Seabrook Station

Procedure ER 5.4, Revision 35

ER 5.4, Protective Action Recommendations, Revision 35

Protective Action Recommendations

Figure 1
Site Area Emergency Protective Action Flowchart

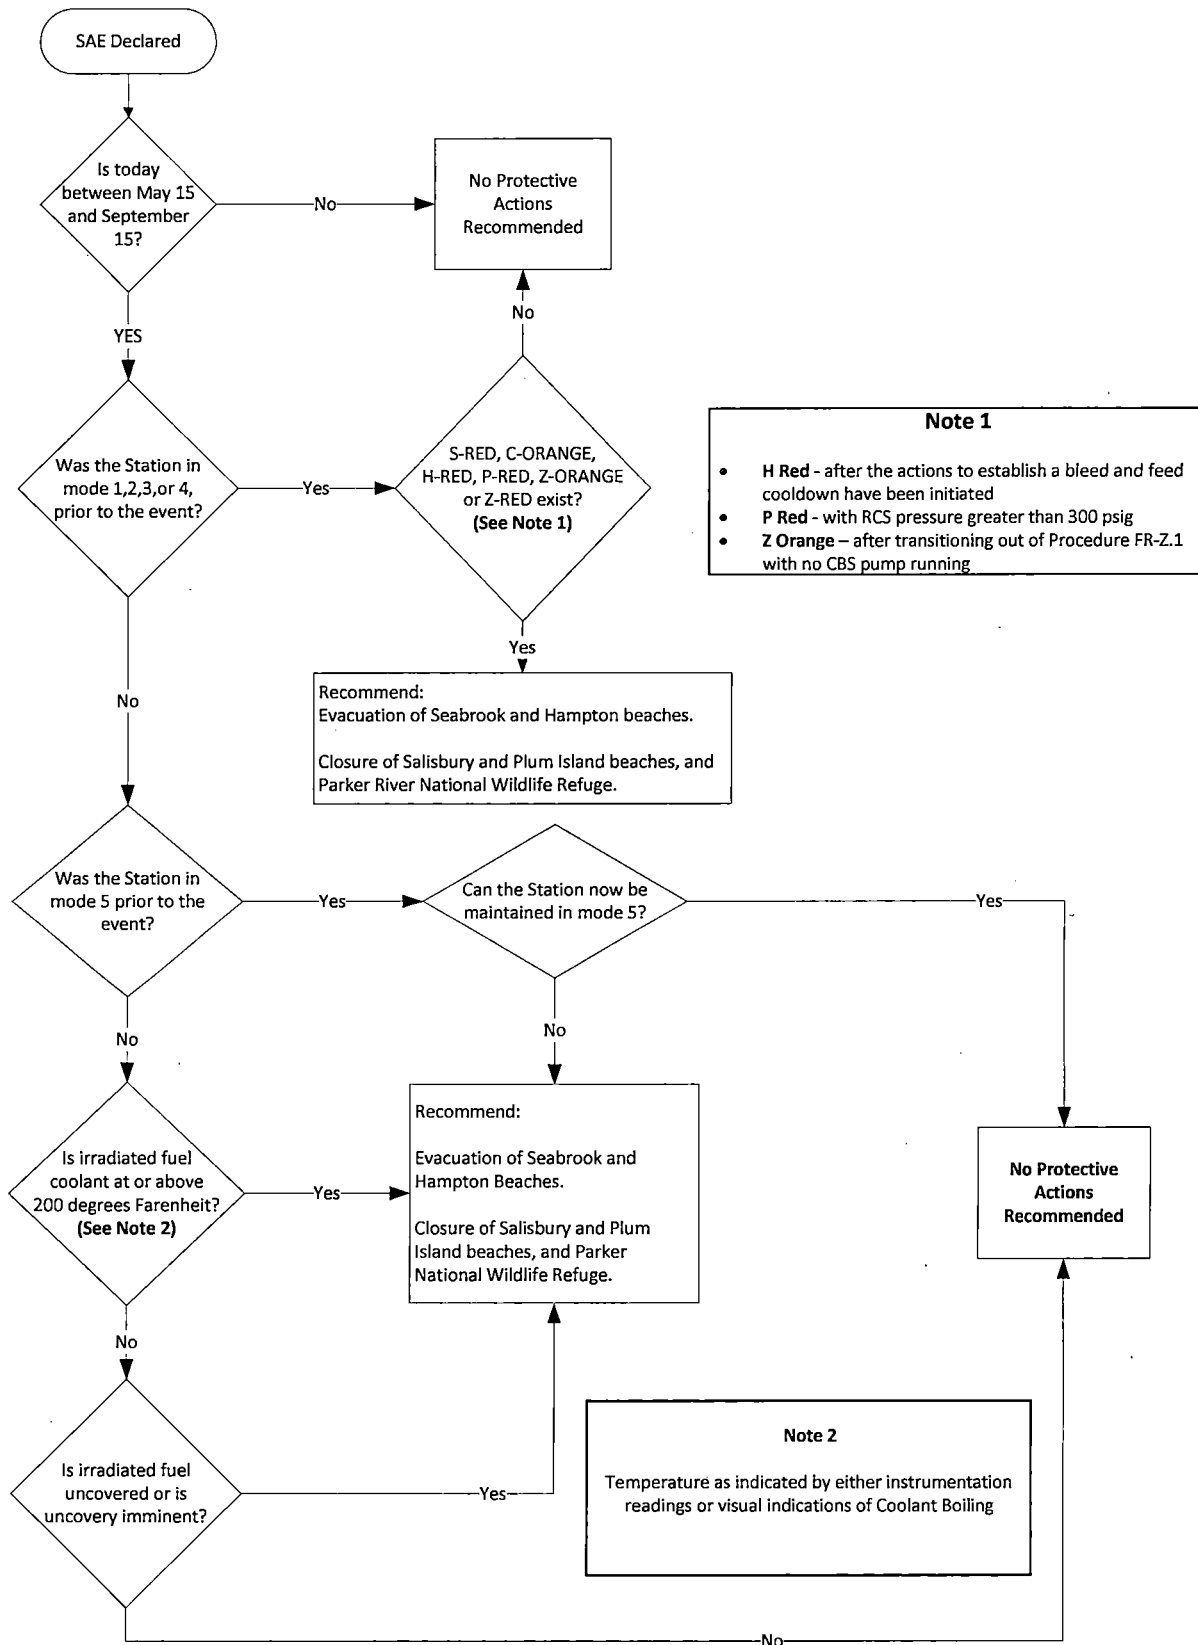
Consolidated Figure 1, Site Area Emergency Protective Action Flowchart into one page.

Figure 2
General Emergency Protective Action Flowchart

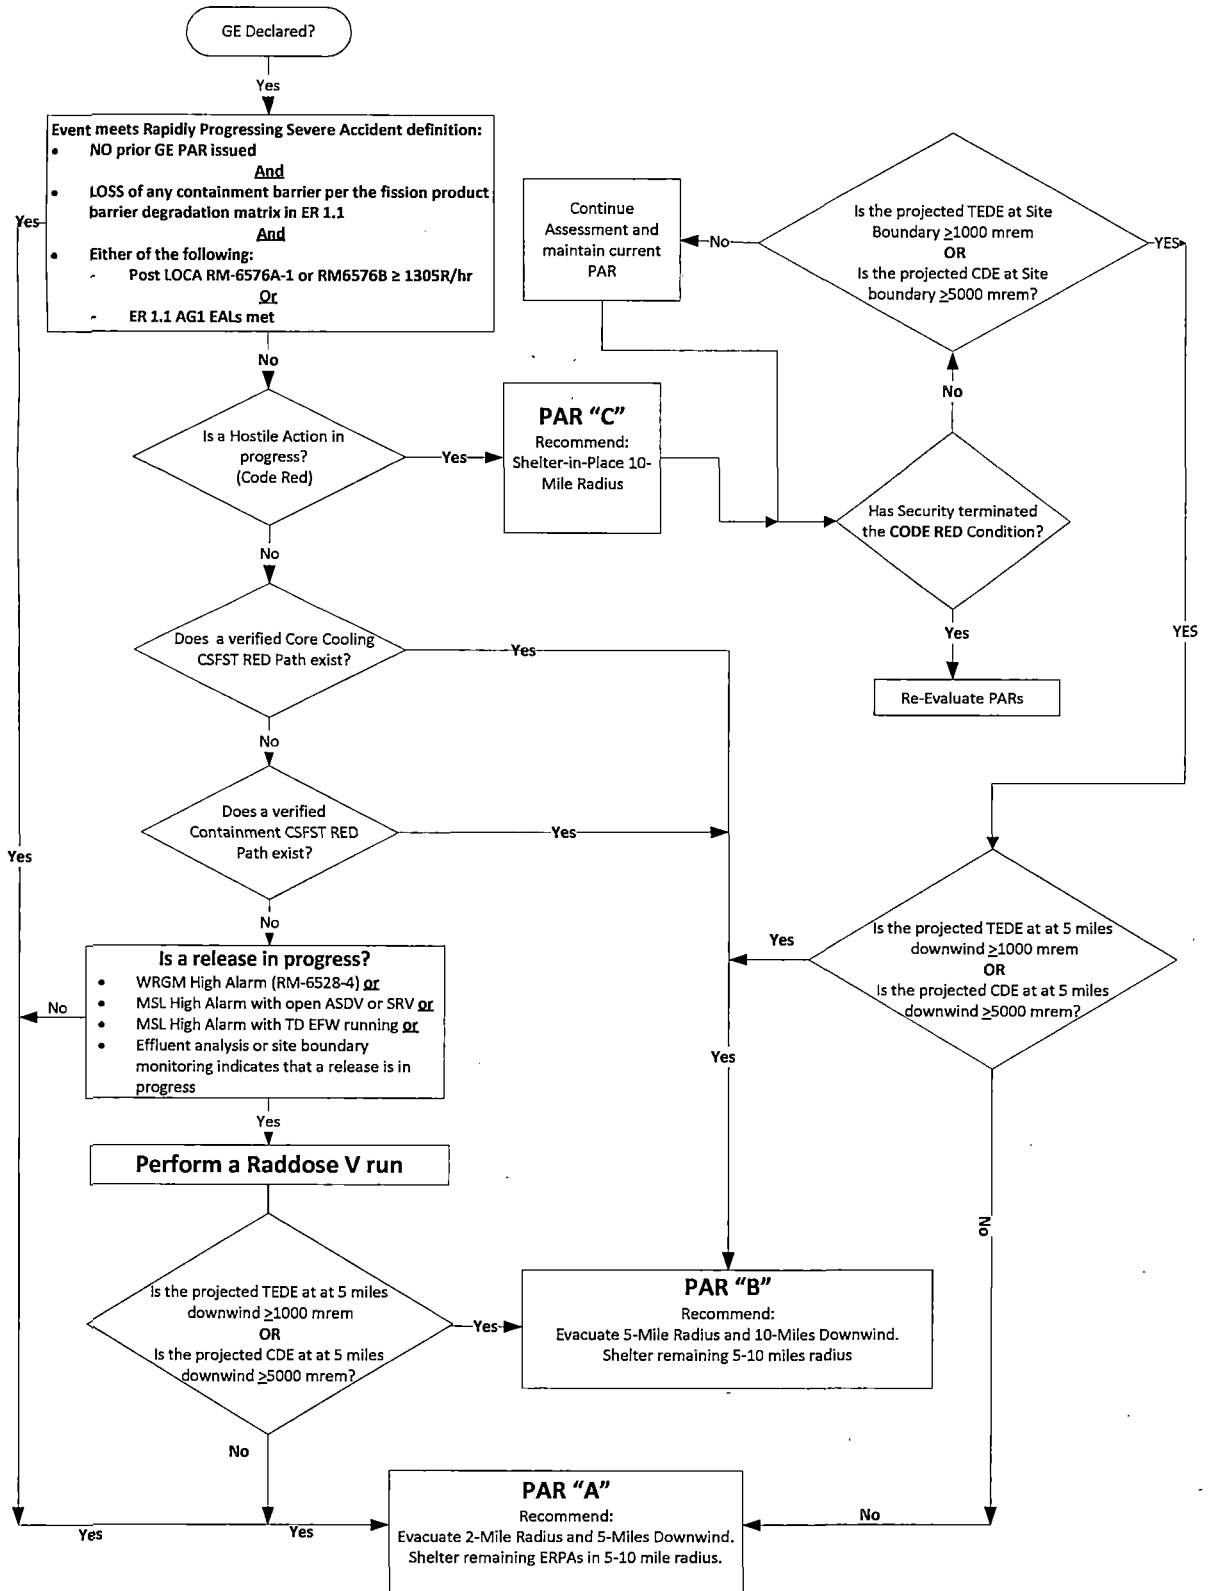
Added a new Figure 2, General Emergency Protective Action Flowchart to reflect NUREG-0654 Supplement 3 PAR Strategy guidance.
